UPLAND SOIL MANAGEMENT PLAN

Re: Evraz Oregon Steel
Shoreline Soil Reuse Plan

Thank you for providing the *Riverbank Source Control Measure Soil Reuse Plan, Evraz Oregon Steel* (May 20, 2015). We approve of the plan but note the following:

To:	Jennifer Sutter, Oregon Department of Environmental Quality
From:	Craig Heimbucher, Integral Consulting Inc.
Cc:	Drew Gilpin and Debbie Deetz-Silva, EVRAZ Oregon Steel Linda Baker – Integral Consulting Inc. Mike Byers – CRETE Consulting
Date:	May 20, 2015
Subject:	EVRAZ Oregon Steel Riverbank Source Control Measure Soil Reuse Plan
Project No.:	C1144-0640

Figure 3.
Berm, Beach, and Alcove Decision/Excavation Units
Evraz Oregon Steel
Portland, OR

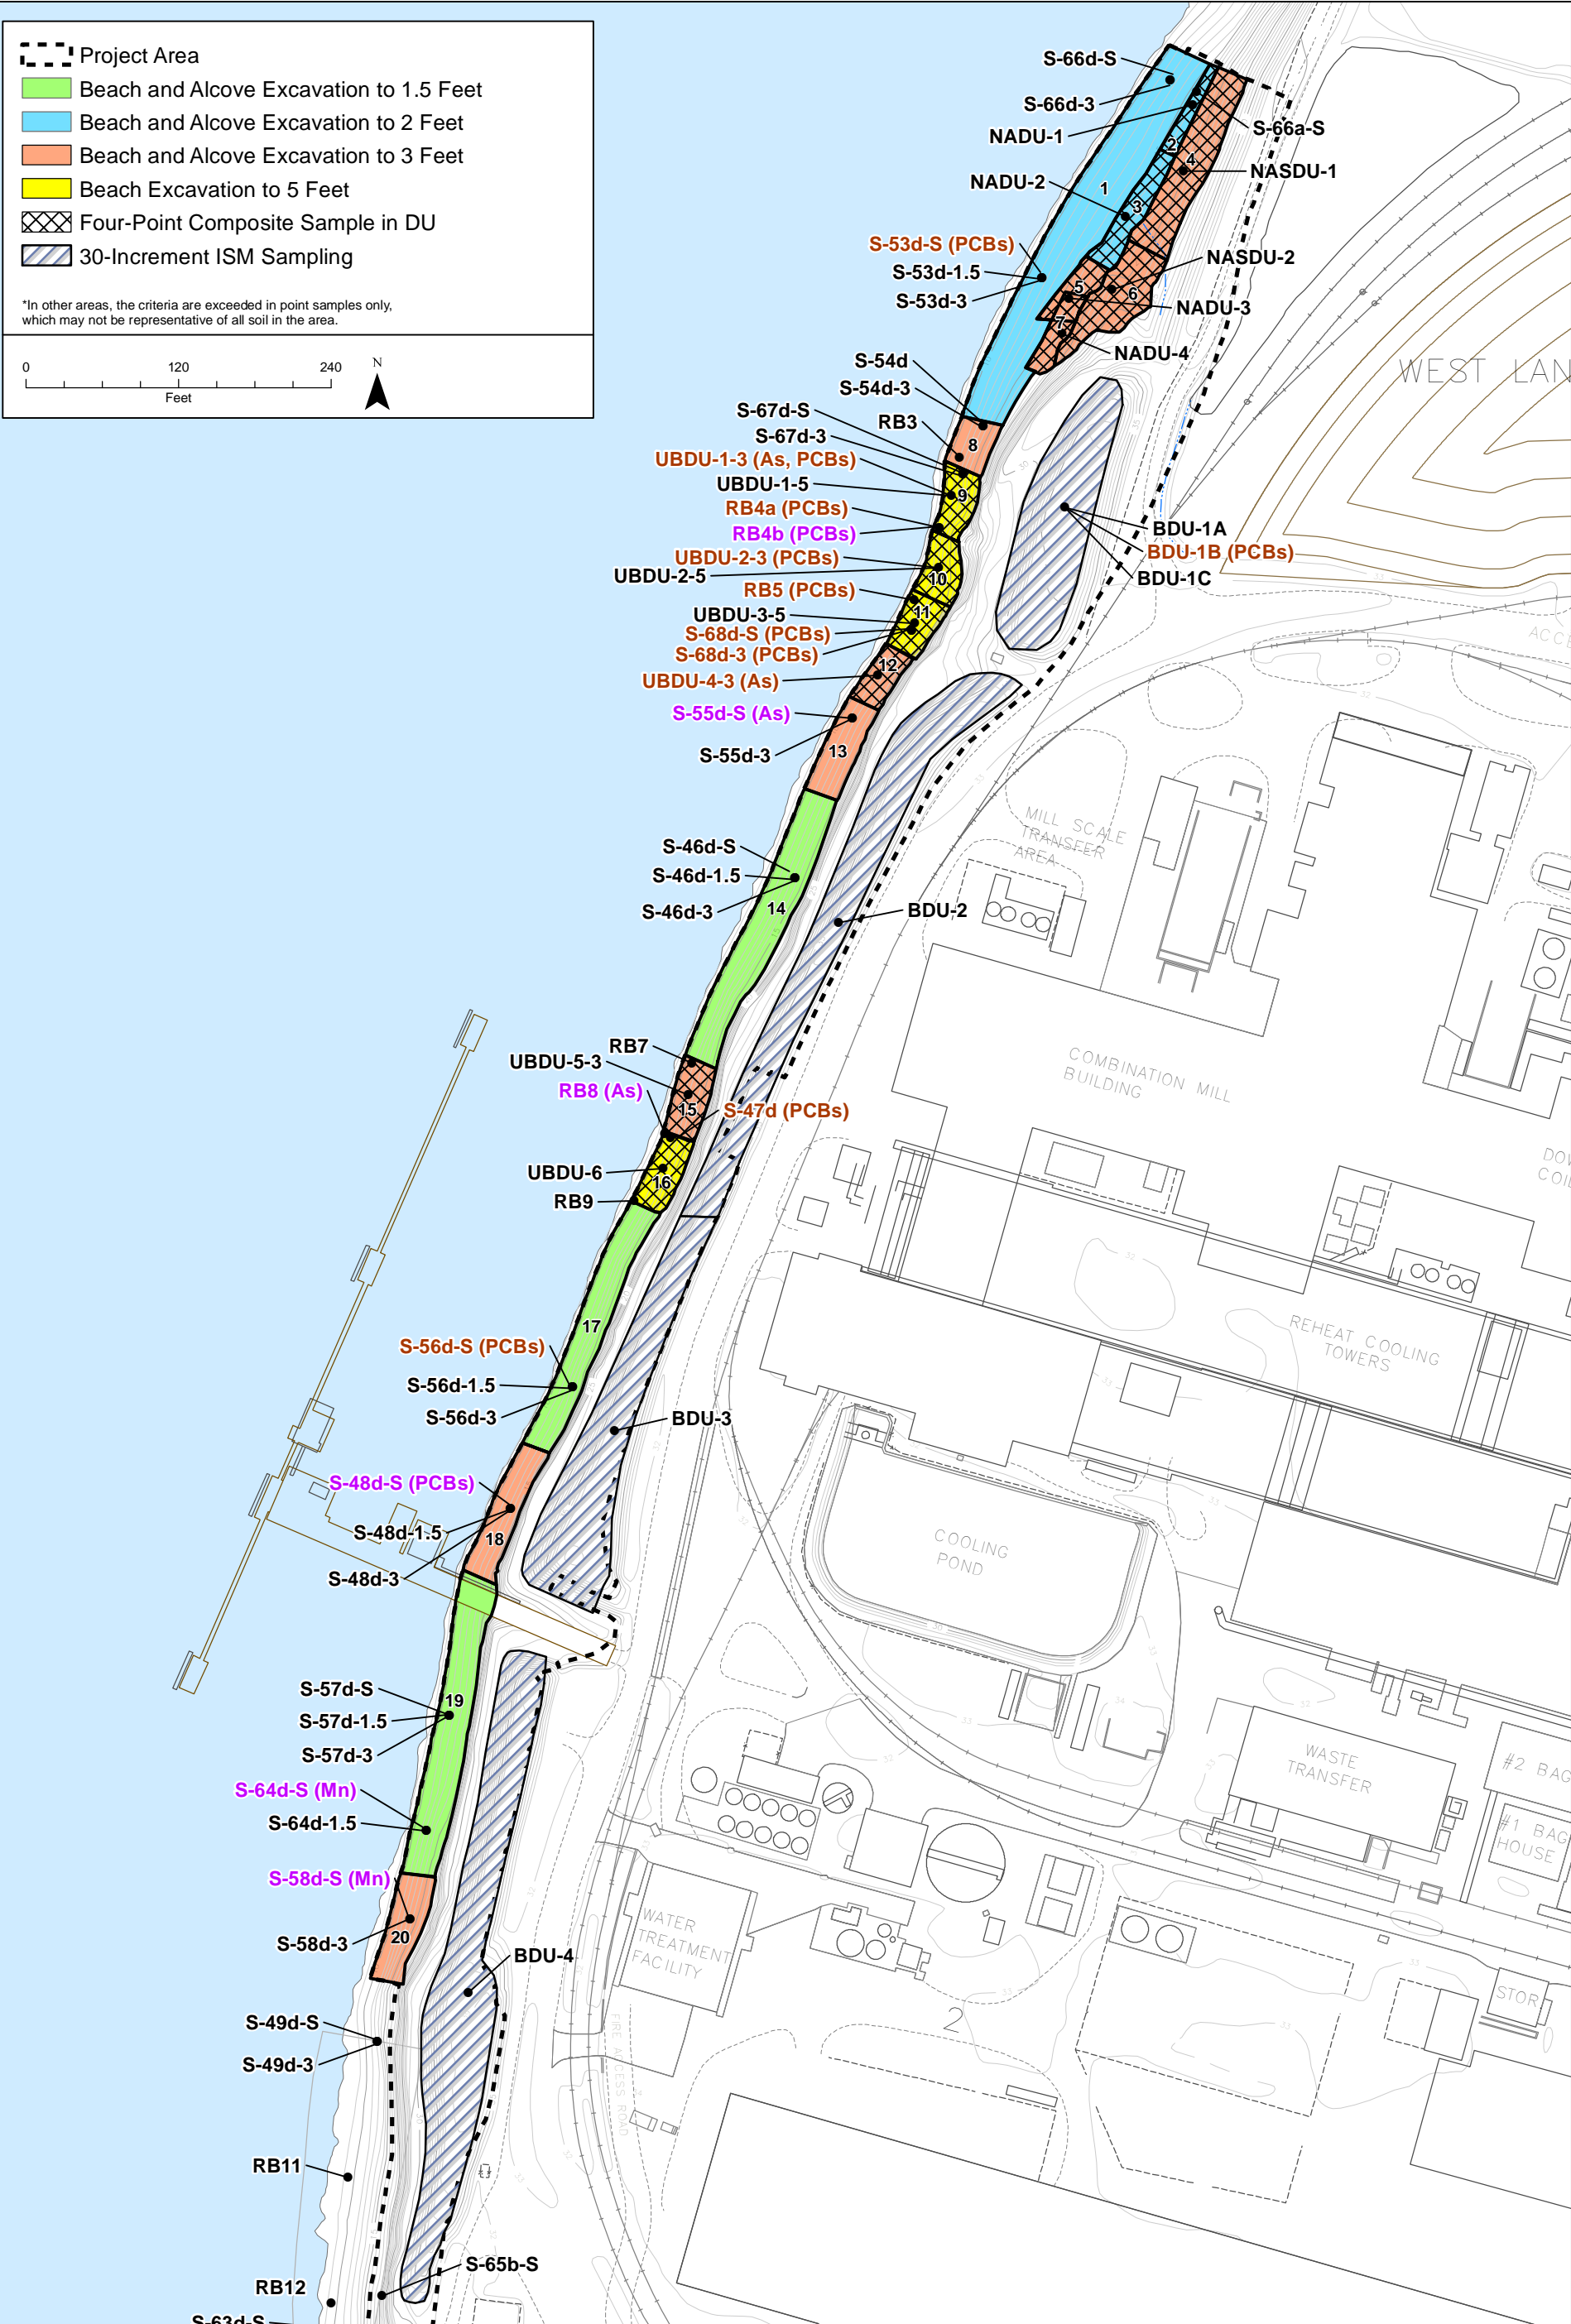
2. Figure 3 indicates that sample S-47d contained PCB concentrations that exceeded surface reuse criteria. Table 2 indicates that the surface sample in this location contained PCBs at 0.44 mg/kg, which is below the surface criteria; and the sample collected at 3 feet below surface, S-47d-3, contained PCBs at 0.88 mg/kg, slightly exceeding the surface criteria.

Figure 5.
Soil Reuse Design
Evraz Oregon Steel
Portland, OR

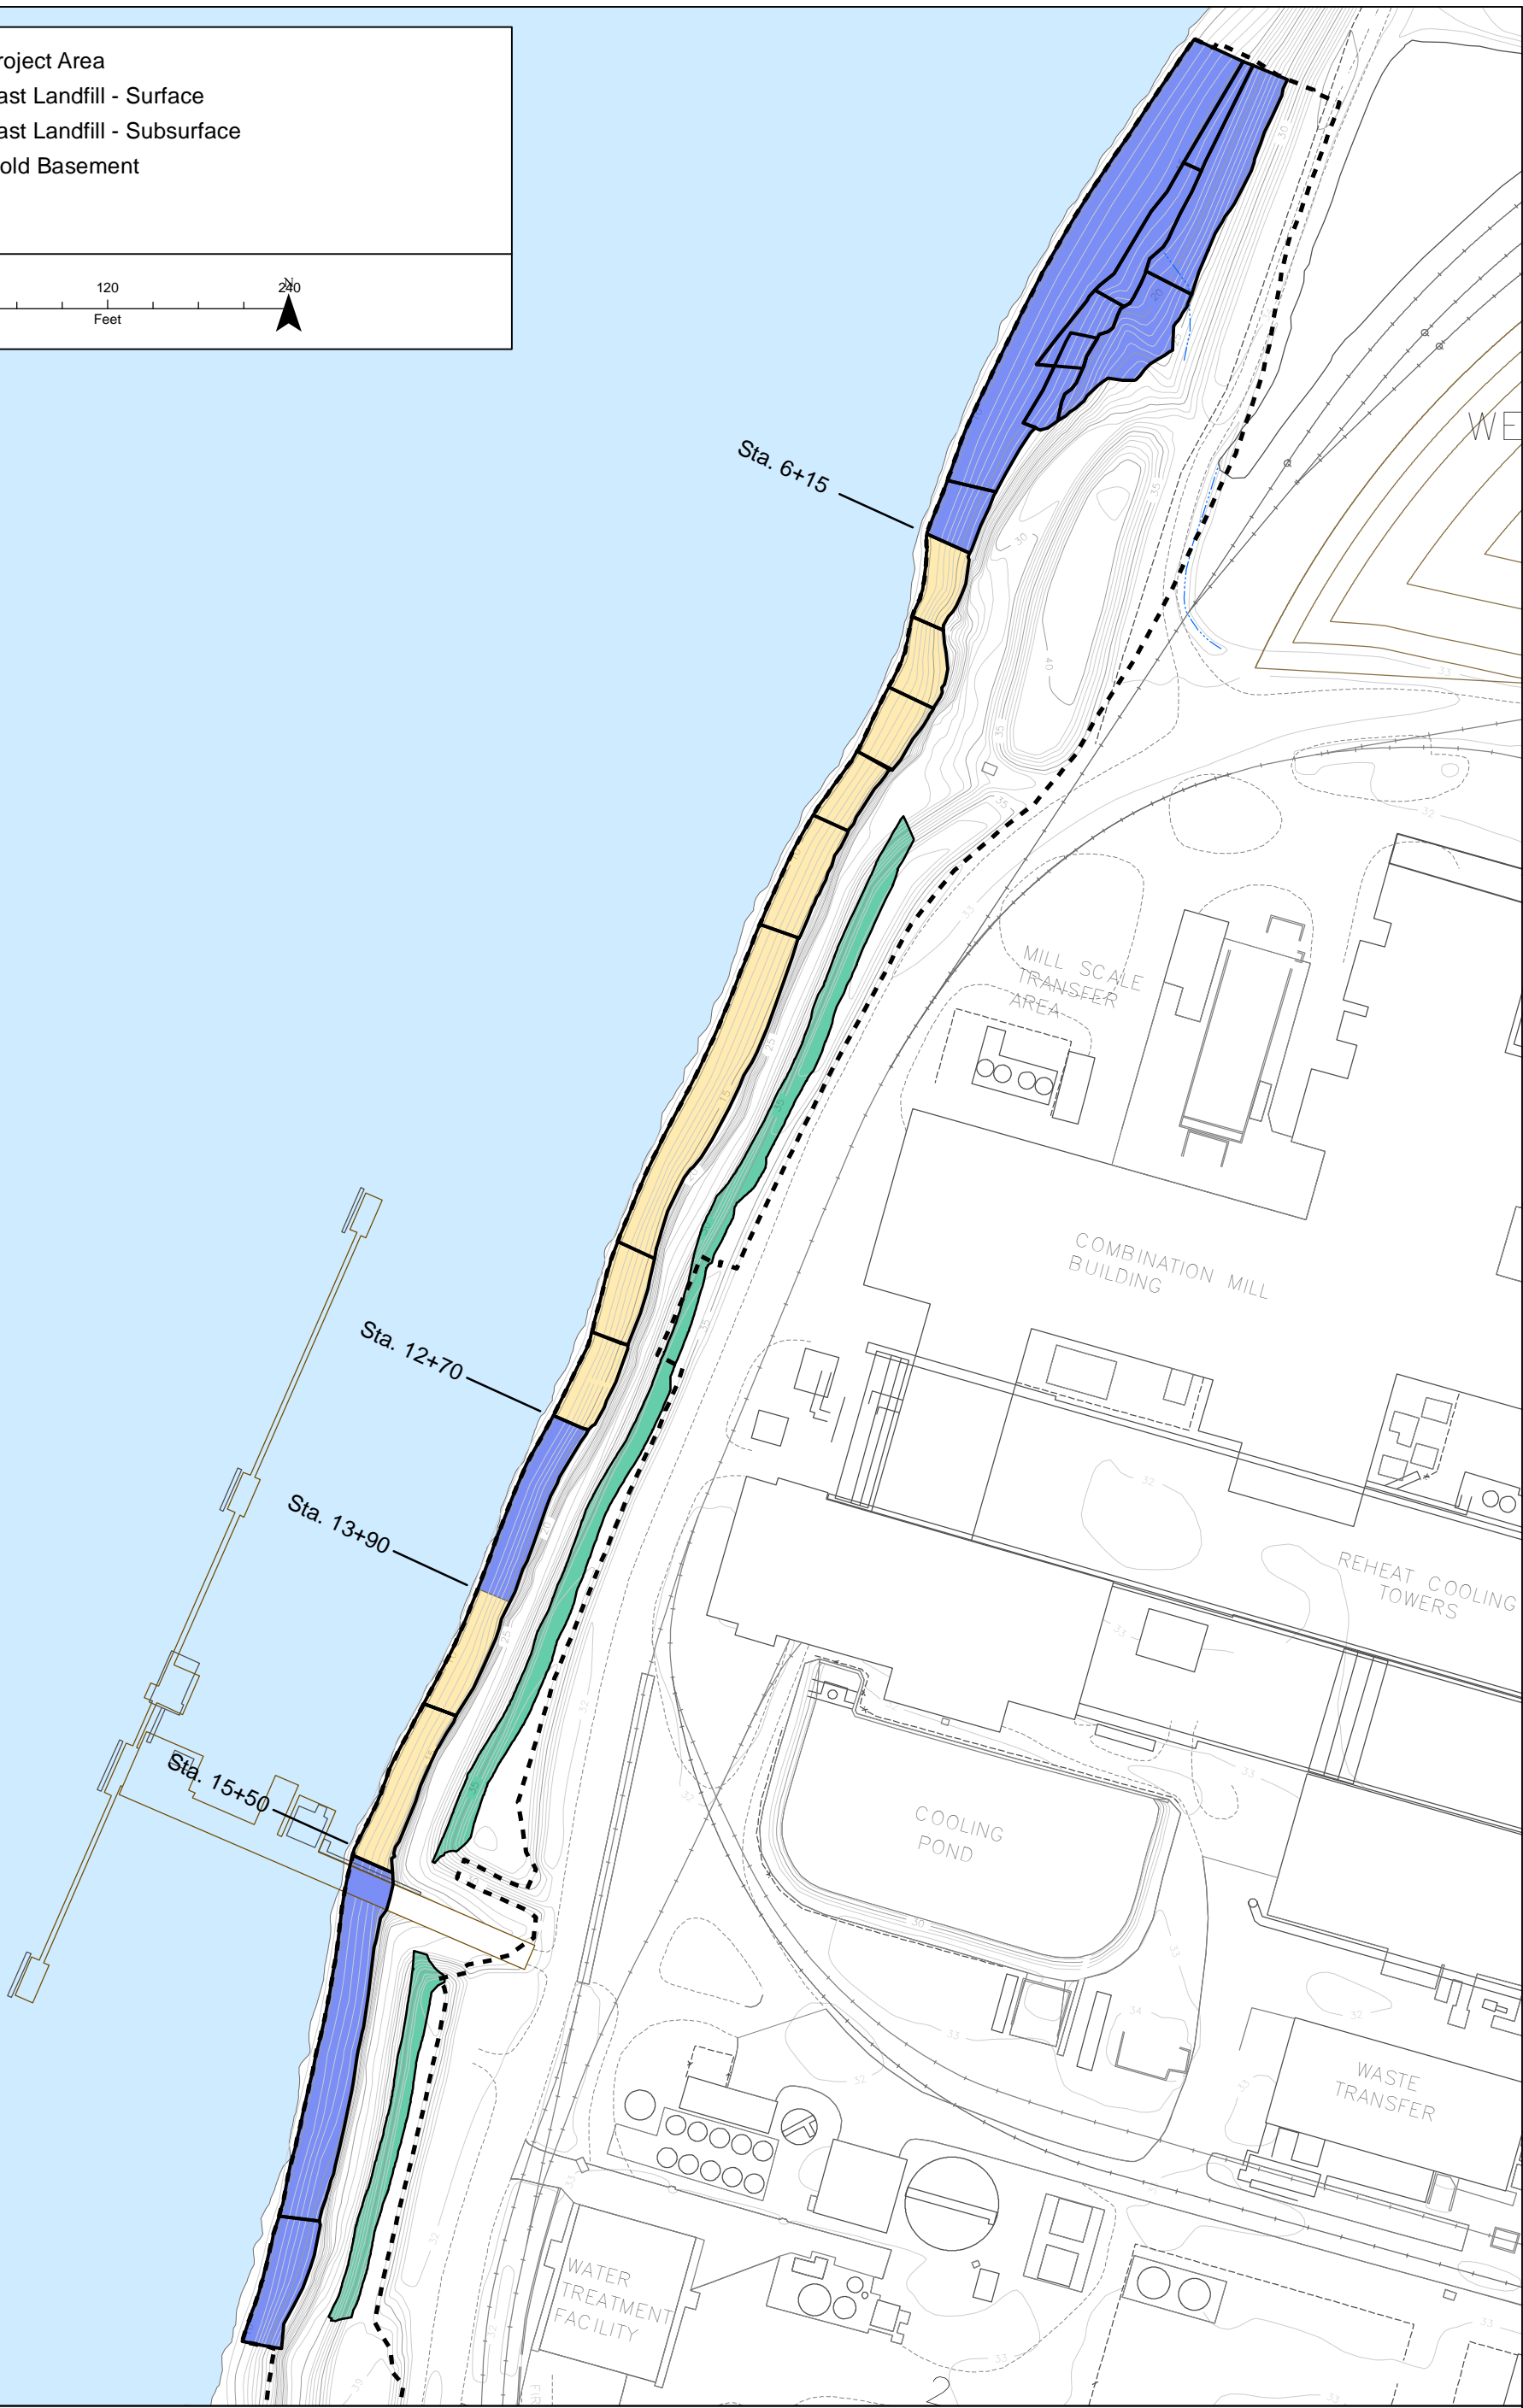
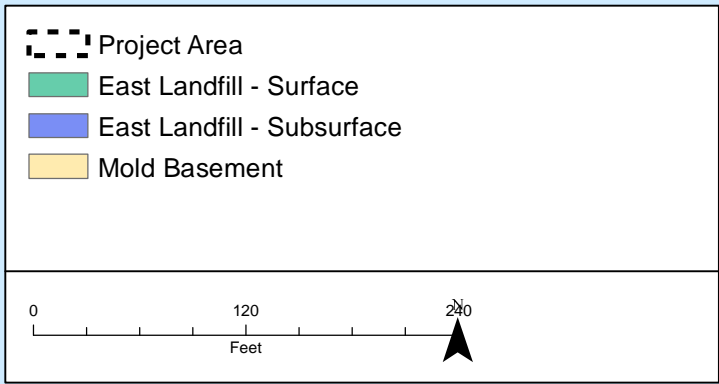
3. Figure 5 indicates that there is an approximately 120-foot segment of the beach between Stations 13+90 and 12+70 from which excavated material will be placed in the east landfill area. There appears to be limited sampling data in this area and the portion of the beach just south of this segment has some of the highest concentrations of PCB detected in the beach. If capacity of the mold basement is limited, it may be more appropriate to place material from the S-46 to S-55 section of the beach in the landfill and place material from this segment in the mold basement.
